Chain Valley Colliery Consolidation & Extension

Reasons for Objection – John Shiel PhD(Eng)

Vales Point Power Station, Not required due to one year of Solar Installations

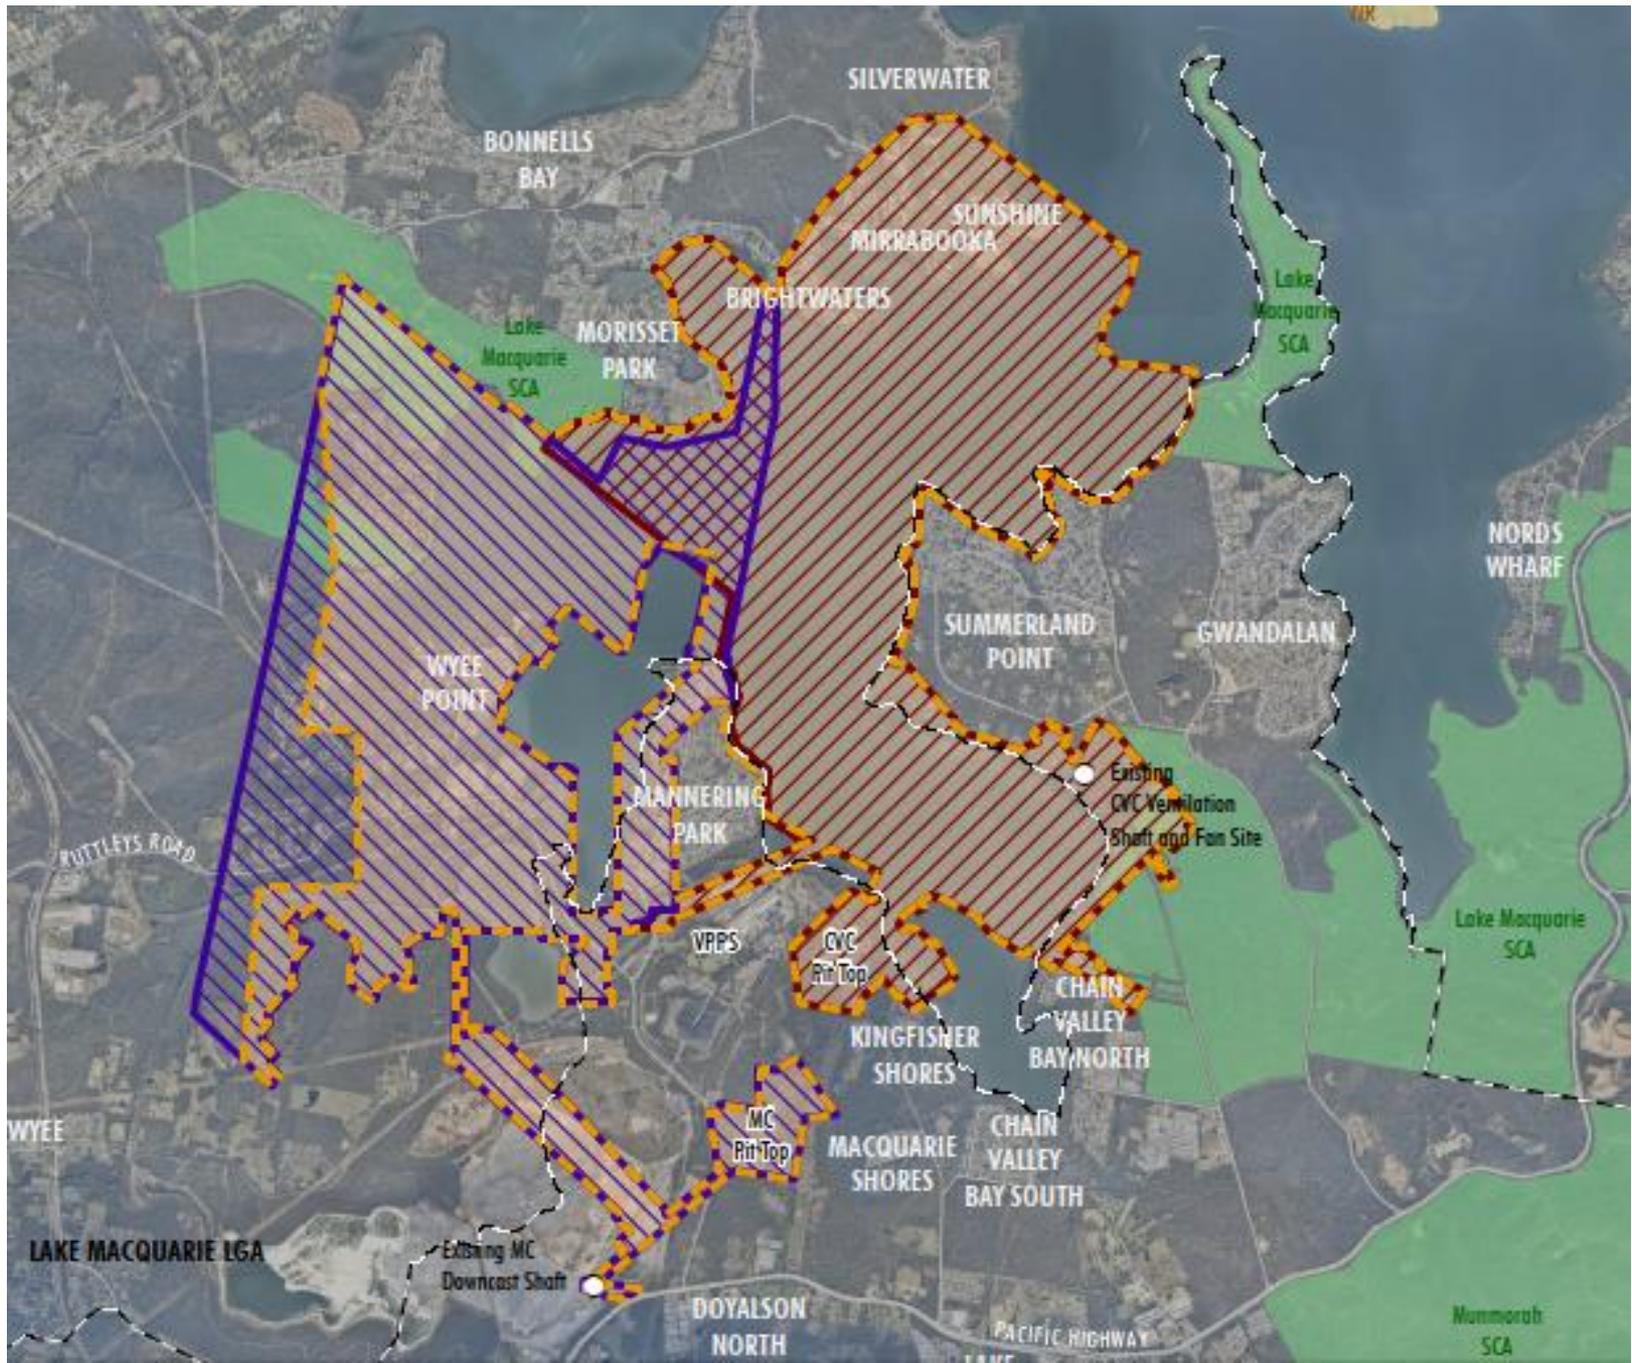
Vales Point supplies
2x 660MW at 50%
Capacity factor
= **660MW**

In 2024 calendar year, Rooftop Solar installed 3.2GW &
Large Scale solar installed 1.2GW (CEC, 2025 p.69)
 $3.2 + 1.2 \text{ GW} = 4.4 \times 1000 \text{ MW}$
 $= 4,400 \text{ MW}$ with 16.7% capacity factor (4 hours per day)
 $= \mathbf{733 \text{ MW}}$ supplied by solar

Proximity of Mining to Ash Dam

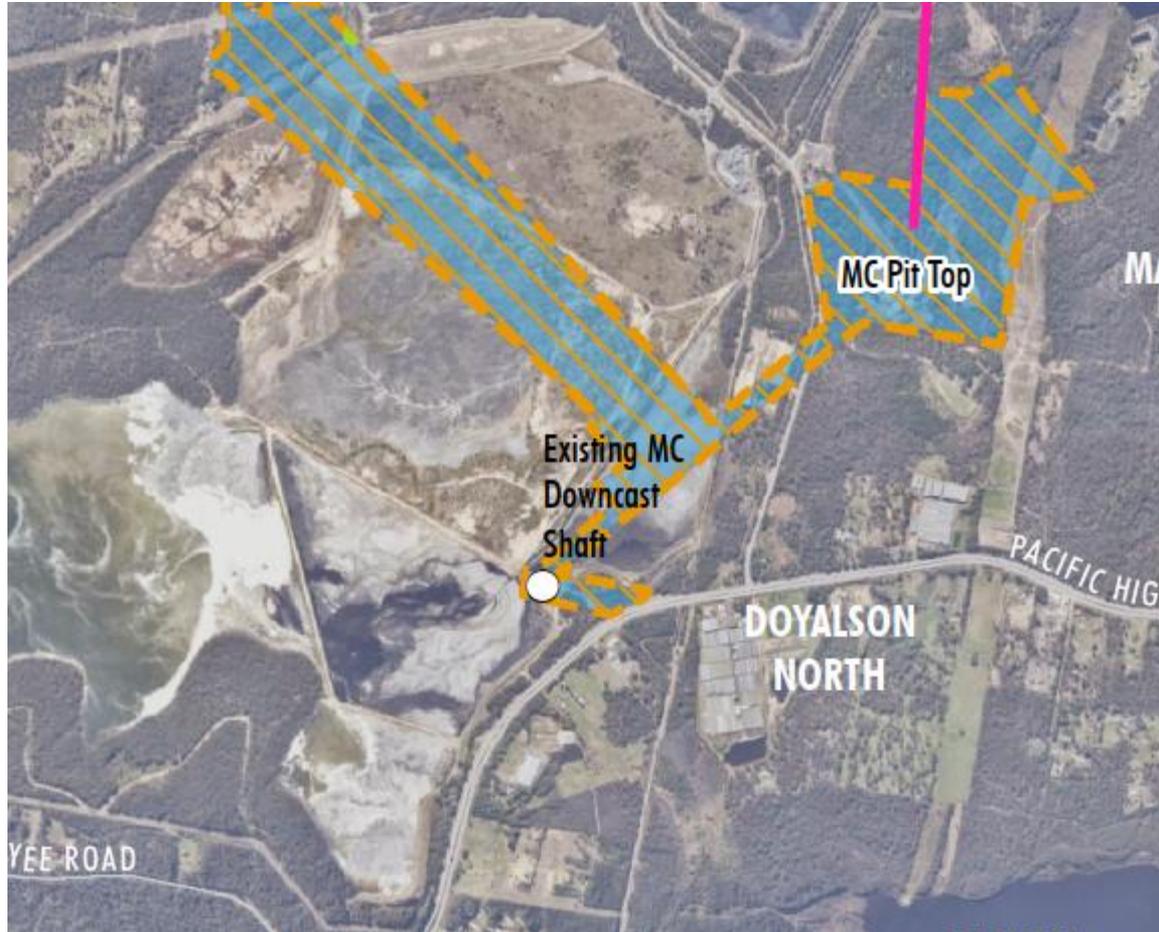
- Continued mining under Lake Macquarie
 - Risking a larger settlement area
 - Water table disturbance
 - Fishing
- Ash dam
 - Fly ash is at risk of earthquake - Myuna Dam Recreation Area was closed immediately upon the release of the Fly Ash Risk Report (Wakatama & Farquhar, 2019).

Figure 14: PM_{2.5} Particulate at Wye Air Quality Monitoring Station

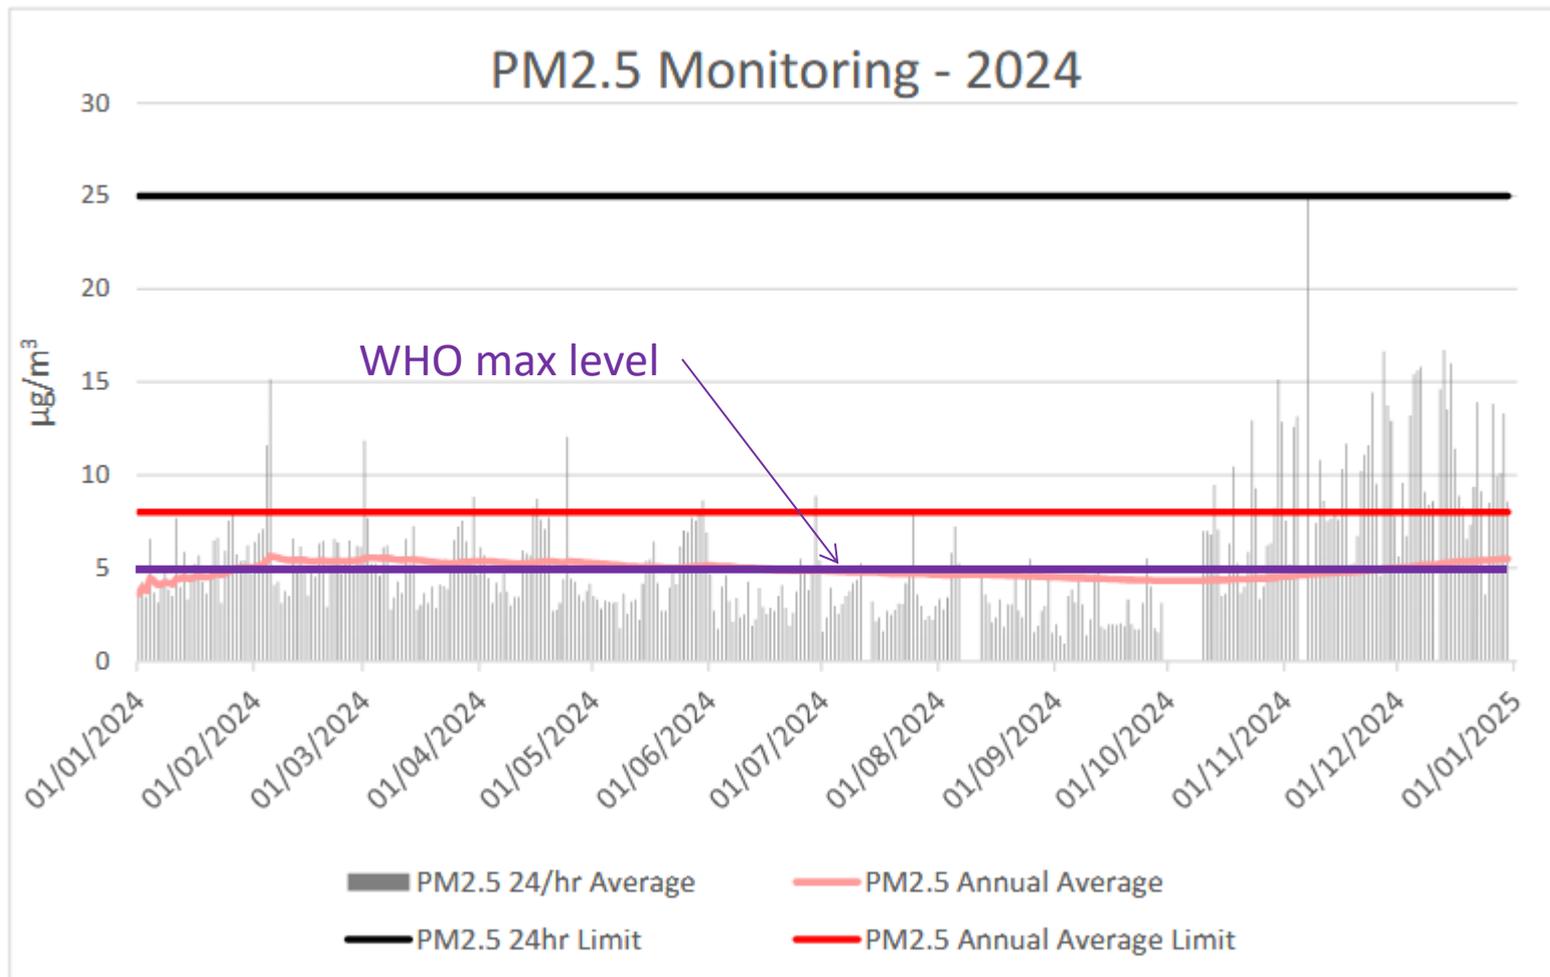
- EPA ignored WHO PM_{2.5} guidelines of 5 µg/m³ (there is no safe level of PM_{2.5} particulates)
 - VPPS one of few power stations in the world given an EPA licence exemption to pollute (PM_{2.5}, Nitrates, Sulphates etc.) at the expense of the health of the locals (asthma, cancers) (Ewald, 2018)
